# ***Interactive comment on* “New measures of deep soil water recharge during vegetation restoration process in semi-arid regions of northern China” by Yiben Cheng et al.**

Received and published: 7 August 2020

Fig. 1.

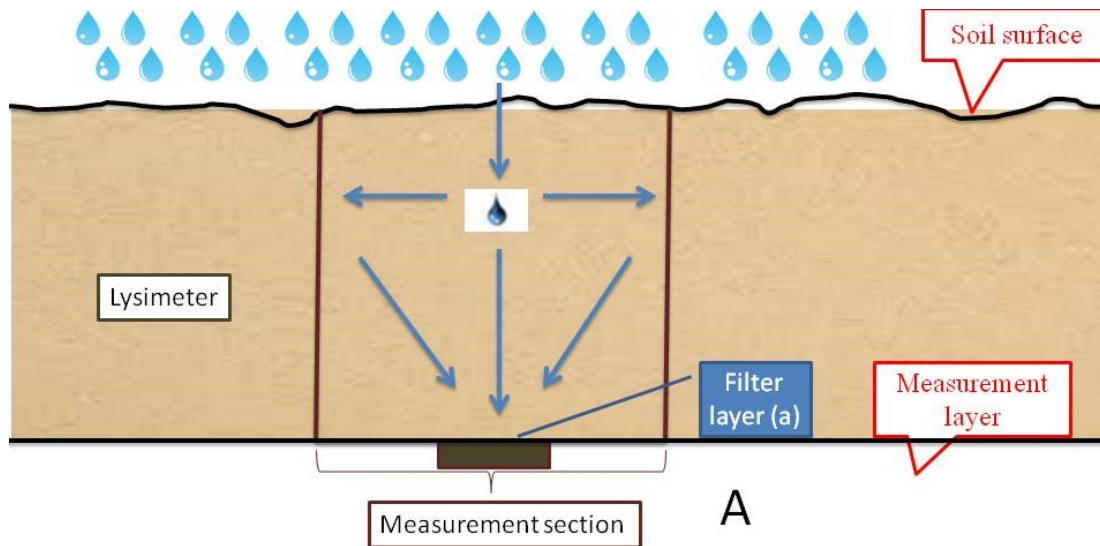
L133: Since the *Artamisia sphaerocephala* Krasch developed horizontal root, is it too small to excavate a length and width both of 0.3m soil column or design such size of a lysimeter?

Response: Thank you for the comment. The conventional Lysimeter uses an impermeable container (constructed all the way from ground surface downward) to wrap the soil column, blocking the horizontal flow of the soil layer in the root zones(see supply figure A, the conventional Lysimeter; figure B, the new Lysimeter). It is notable that horizontal soil moisture flow in the active root zones in arid and semi-arid regions could be significant as the roots prefer to grow horizontally to intercept the maximum infiltrated water. In arid and semi-arid regions, the roots usually do not grow vertically to great depths because the regional groundwater table is so deep that it is almost impossible for roots to tap groundwater. Below the active root zones, horizontal movement of water moisture will be substantially reduced and vertical movement of water moisture starts to prevail. Meanwhile, if a conventional Lysimeter is used, the vegetation needs to be

transplanted into the container, so the soil structure and the vegetation root system will be disturbed. The new Lysimeter of this study is designed to be a small-sized instrument installed at any targeted depth of soil layer below the active root zones in arid and semi-arid regions, without blocking possible horizontal water moisture movement in the active root zones. The plot selected for the experiment is the artificially restored ASK sand-fixing land. The terrain is widely distributed in the Mu Us sandy land and is relatively flat. ASK is the main vegetation species and the soil types is sandy soil. Under these rather “homogeneous” conditions, the experimental result of selected plot may be representative of the ASK sand-fixing land region. However, we do want to point out that one should be cautious for conducting any upscaling of local value of evapotranspiration to large-scale evapotranspiration value. The groundwater is deeply buried in the selected plot (around 7 m deep) so the roots of ASK (which is usually less than 1.2 m deep) cannot tap groundwater for water supply. Therefore, precipitation becomes the only water source supply for ASK to grow. In order to maximize the water taking capability, the ASK root system develops horizontally, making the root layer of the plot relatively evenly distributed in a planar view. The other difference from the traditional Lysimeter is that the measuring face of the new Lysimeter is not only limited to the ground surface. In fact, this newly designed Lysimeter can be embedded in any depths below the active root zones.

Fig. 2.

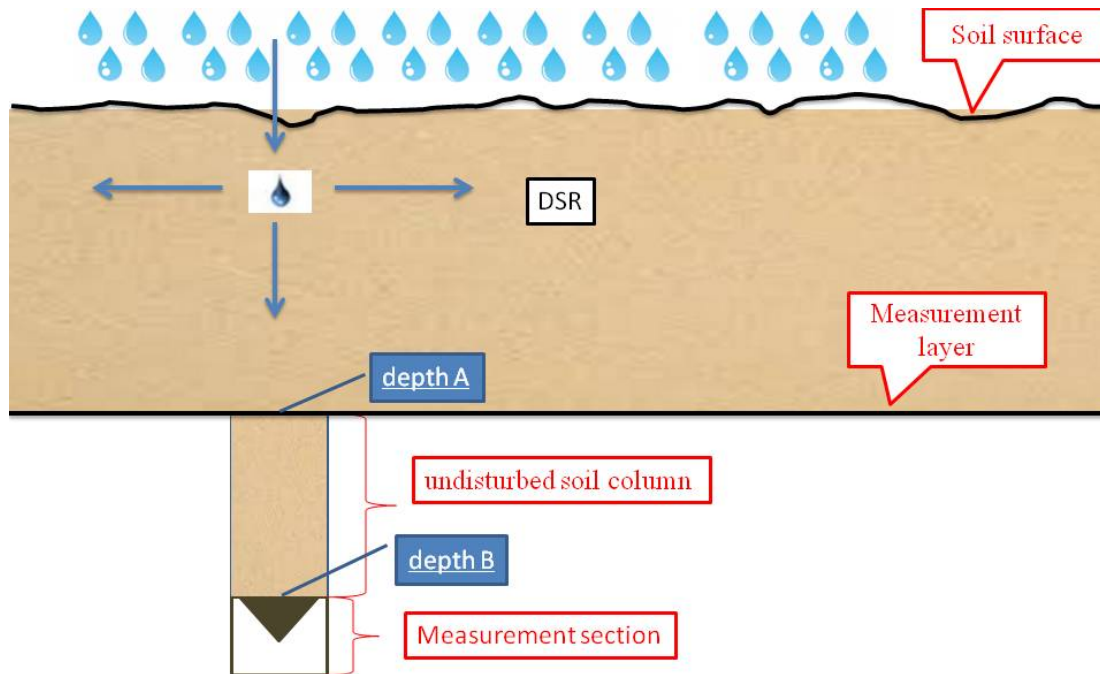
Figure 3 should show the soil temperature curve to identify whether it is soil thawing

period.

Response: We have designed a double-tube apparatus to measure the depth of the freeze-thaw layer depth. The double-tube apparatus consists of a hollow barrel with a vent hole and a rubber tube inside the barrel. First, the hollow barrel with the vent hole is buried vertically in the experimental plot. The upper level of the barrel is at the ground surface and the length of the barrel is 200 cm. The rubber tube filled with water is placed in the cylinder, and it will be extracted at 8PM daily to record the soil frozen state and the frozen depth, which can be used to interpret the thickness of the frozen soil at that moment.
